MEMORANDUM: Robert E. Browning, Director
Division of Waste Management

FROM: F. Robert Cook, Senior On-Site License
Representative, Basalt Waste Isolation
Project (BWIP)

SUBJECT: OBSERVATIONS, COMMENTS AND RECOMMENDATIONS
FOR THE PERIOD JANUARY 17 TO APRIL 3, 1987

Project No. 13891C	WASHINGTON PUBLIC POWER SUPPLY SYSTEM	SHALLOW MICROEARTHQUAKE SWARM OF 2 AUGUST 1979	
Woodward-Clyde Consultants

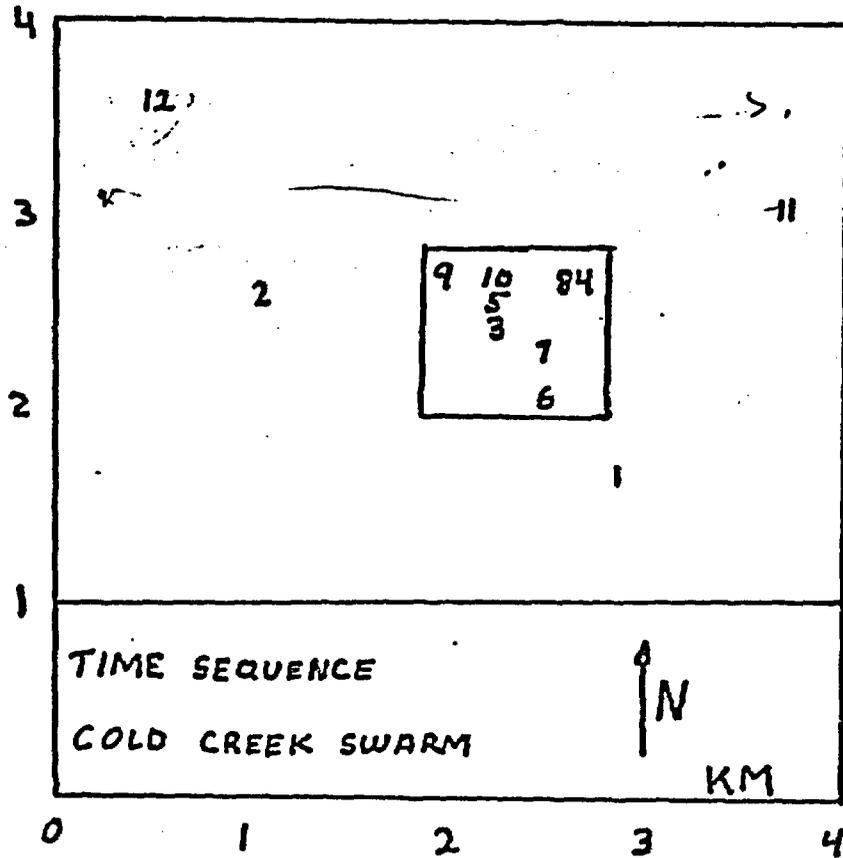
Long plotted wrong

EXTERNAL GOVERNING DOCUMENT

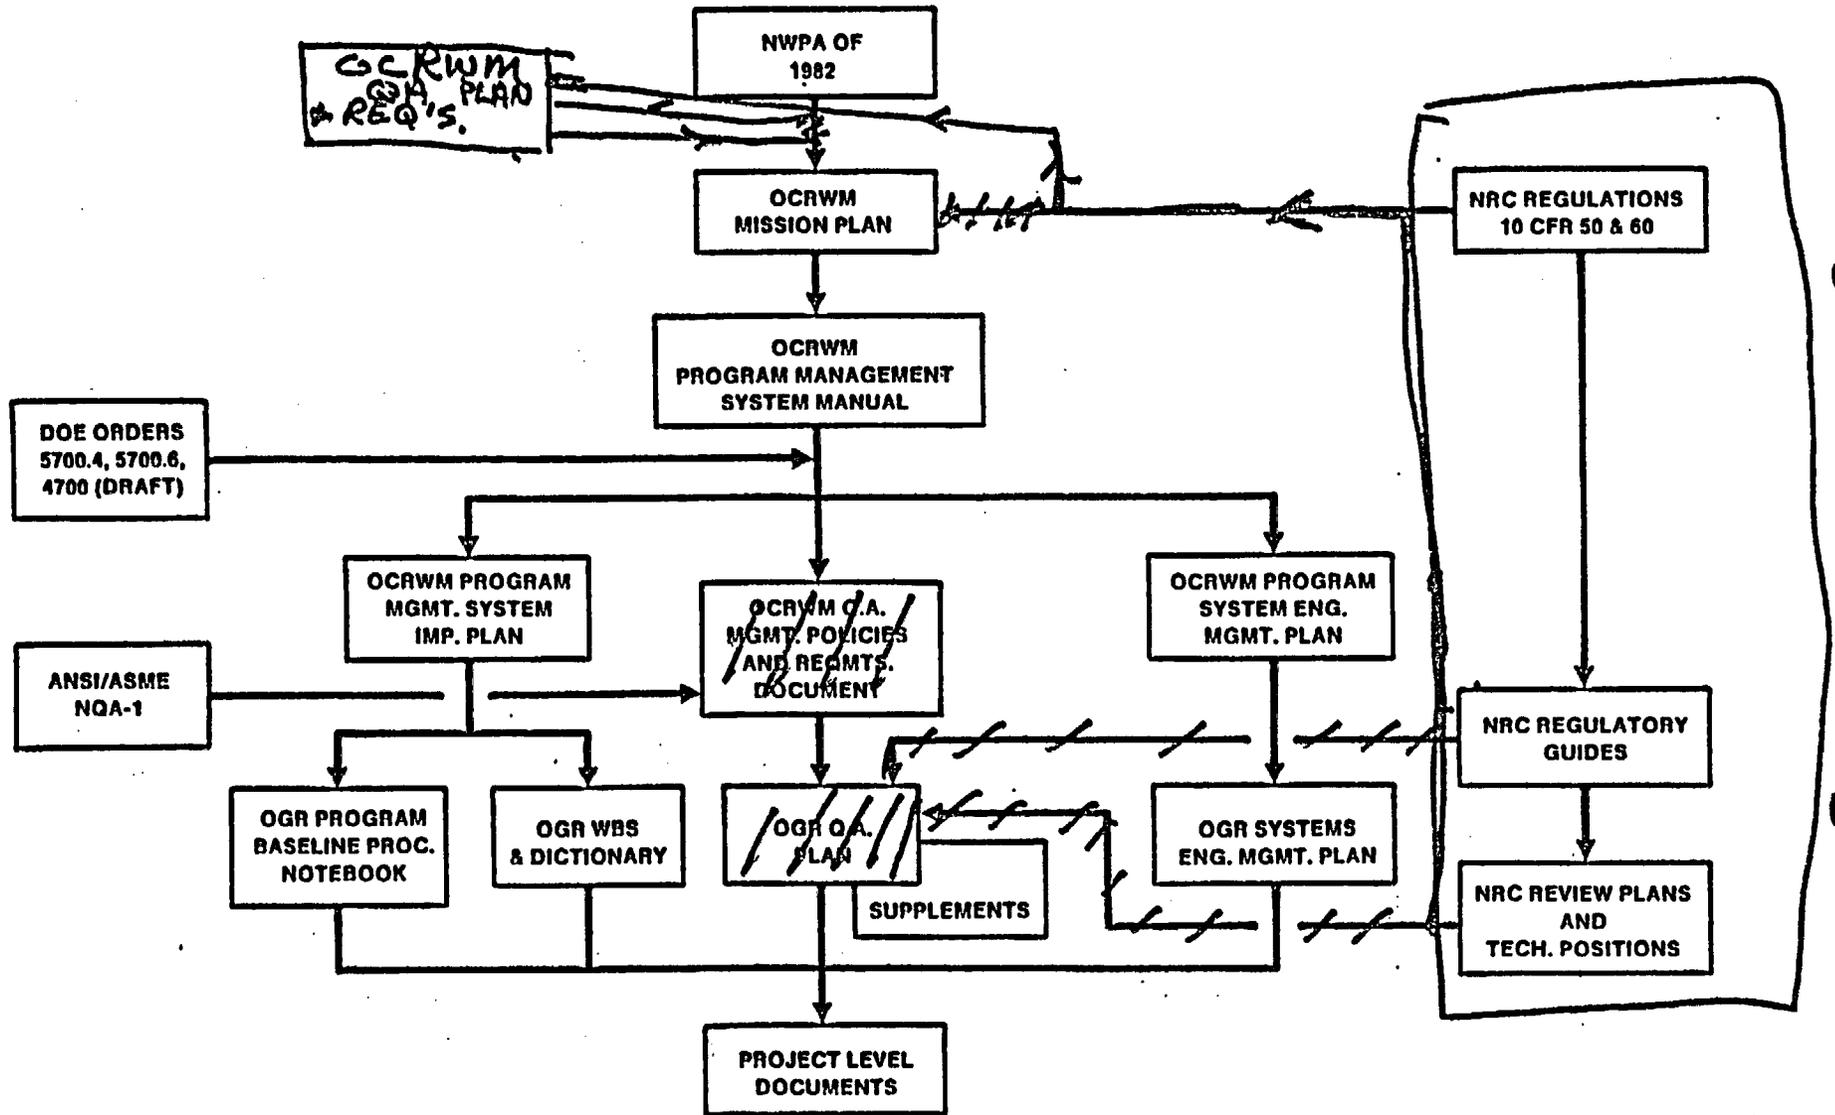
To correct this situation I consider that the hierarchy of requirements documents should clearly list the quality assurance program requirements at the top with lower tier management requirements and procedures and systems engineering requirements and procedures as subsidiary documents. Hence basic orders which DOE specifies for the BWIP, for example, DOE 5700 series orders, should be considered as part of the project's quality assurance program required by the rules of Part 60, assuming the various DOE orders do not conflict with the NRC rules. (Currently there may be conflicts between the requirements of the DOE orders and the requirements of Part 60/50 Appendix B, particularly in so far as these orders specify various quality assurance requirements

contained in NQA-1 at a level above the Appendix B requirements as supplemented by the QA Review Plan. Attachment F identifies the current hierarchy of requirements for DOE/HQ and DOE/RL, marked-up to reflect the possible correction noted herein.

Also it should be noted that the requirements stemming from the Mission Plan appear in the hierarchy presented by DOE at a higher level than the quality assurance plan. Since the Mission Plan is in part a scheduling document, which schedule results from coordinating funding restraints and technical requirements and procedures in order to achieve quality in the technical products of the project, it is incorrectly placed in the hierarchy as indicated in the mark-up of Attachment F. In particular the schedular part of the Mission Plan should not appear to the participants as a requirement, if quality of the technical products is to be preserved.

EXTERNAL GOVERNING DOCUMENT

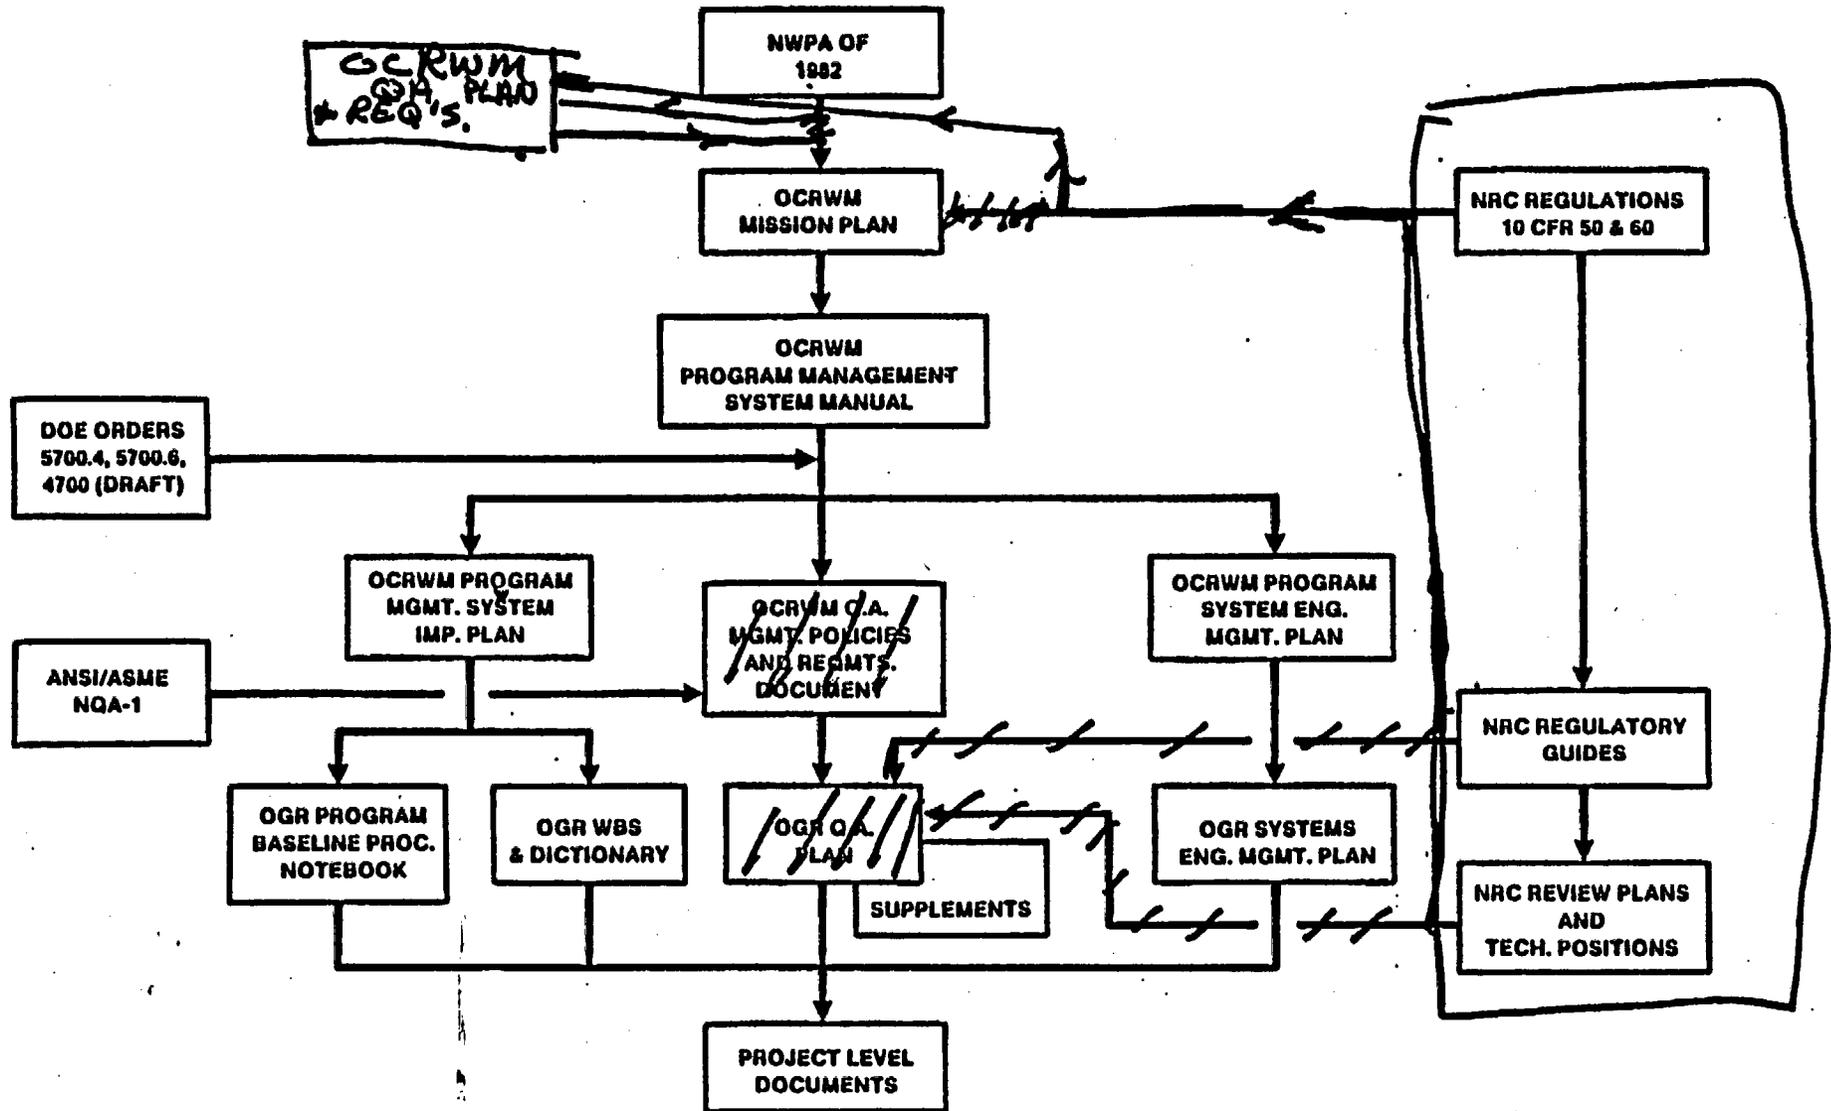
To correct this situation I consider that the hierarchy of requirements documents should clearly list the quality assurance program requirements at the top with lower tier management requirements and procedures and systems engineering requirements and procedures as subsidiary documents. Hence basic orders which DOE specifies for the BWIP, for example, DOE 5700 series orders, should be considered as part of the project's quality assurance program required by the rules of Part 60, assuming the various DOE orders do not conflict with the NRC rules. (Currently there may be conflicts between the requirements of the DOE orders and the requirements of Part 60/50 Appendix B, particularly in so far as these orders specify various quality assurance requirements

contained in NQA-1 at a level above the Appendix B requirements as supplemented by the QA Review Plan. Attachment F identifies the current hierarchy of requirements for DOE/HQ and DOE/RL, marked-up to reflect the possible correction noted herein.

Also it should be noted that the requirements stemming from the Mission Plan appear in the hierarchy presented by DOE at a higher level than the quality assurance plan. Since the Mission Plan is in part a scheduling document, which schedule results from coordinating funding restraints and technical requirements and procedures in order to achieve quality in the technical products of the project, it is incorrectly placed in the hierarchy as indicated in the mark-up of Attachment F. In particular the schedular part of the Mission Plan should not appear to the participants as a requirement, if quality of the technical products is to be preserved.
